Technical Bulletin

TB-76 / December 18, 2014

Simrad Technical Bulletin for MX61x/GN70 CDU and GS70 Antenna Software

Product: GN70/MX61x, MX61xJB and GN70 Smart Antenna

Diagram 1: Programming setup with external 12 VDC supply

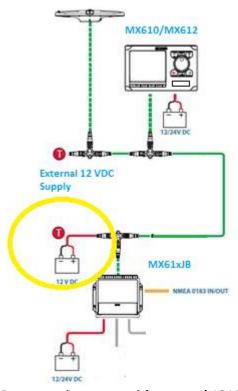
An external 12 VDC supply to the NMEA 2000® bus is required for upgrading the MX610JB/MX612JB junction box software as the internal supply will be switched off during the upgrade process and programming will fail. See the diagram below.

Note: The junction box software must be updated first before updating the display
